Service Advisory

Applicable Games: Rush

Models: Premium, LE

Serial Numbers: All numbers before #330402C

Previous Switch and Bracket

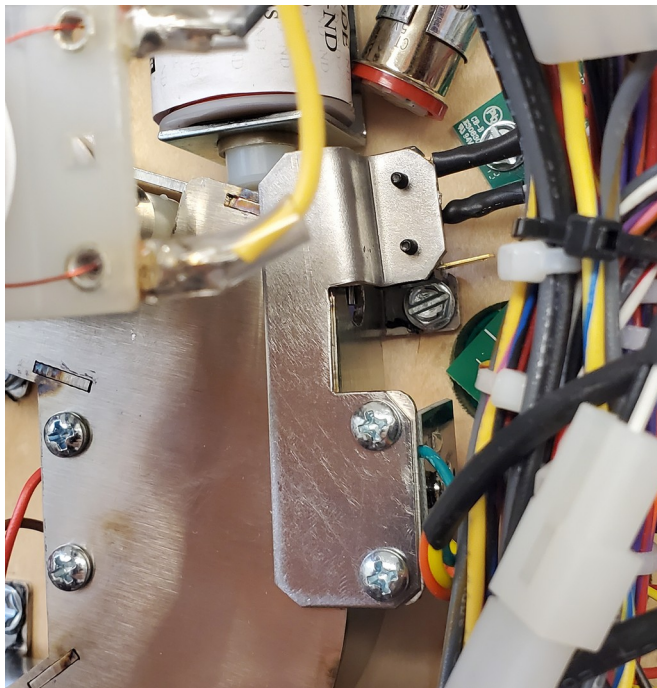
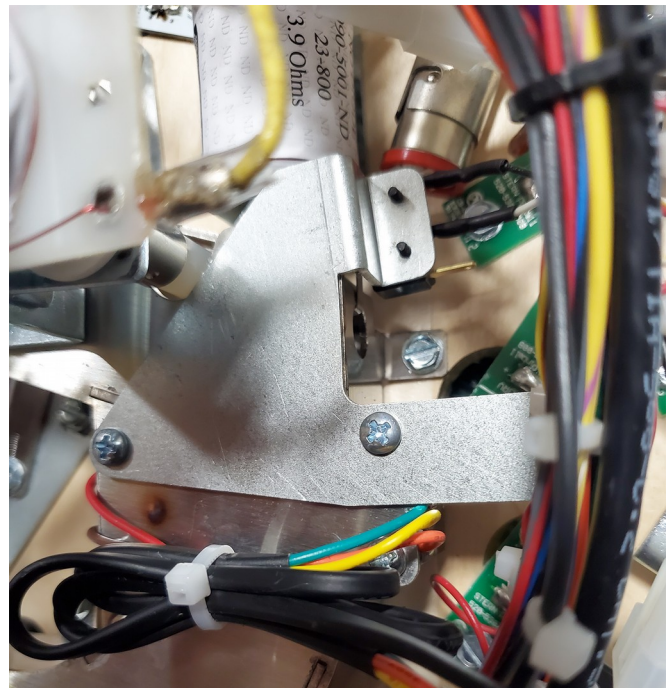
To improve the switch activation of switch #41 (Lower Side Scoop), our mechanical engineering department highly recommends replacing the current switch and bracket assembly on your game with kit number 502-8018-00; reference the pictures below. Please contact your distributor if your game requires this kit.

New Switch and Bracket
